Road & Bridge Design Publications

Monthly Update – December 2012

Bridge Design Manual

7.02.20

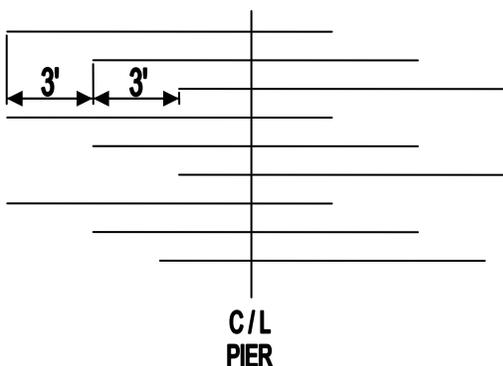
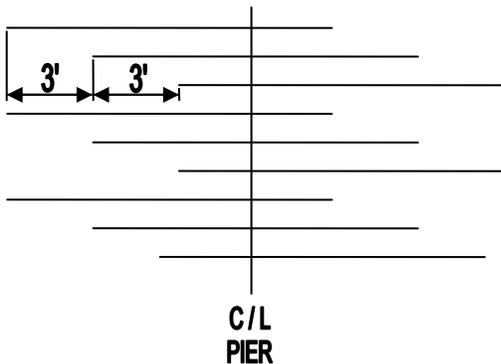
7.02.20 A. (LFD & LRFD): Deleted the language on length of reinforcement in cantilever spans. Designs should be according to AASHTO LRFD section 5.11.1.2.3.

Additional longitudinal reinforcement is required in regions of negative moment (see AASHTO 10.38.4.3). Bar ends should have two 3' staggers (see below) to minimize transverse cracking at bar terminations.

With continuous beam design, the bar length should be according to AASHTO 10.38.4.4.

Where additional longitudinal reinforcement is required in regions of negative moment see AASHTO LRFD A 6.10.1.7. If the longitudinal reinforcement is considered to be a part of the composite section, shear connectors shall be provided in negative flexure regions. Where shear connectors are used in negative flexure regions, the longitudinal reinforcement shall be extended into positive flexure region (AASHTO LRFD A 5.11.1.2.3). (8-20-2009) (12-22-2011)

Bar ends should have two 3' staggers (see below) to minimize transverse cracking at bar terminations.

With continuous beam design, the bar length should be according to AASHTO LRFD 5.11.1.2.3.
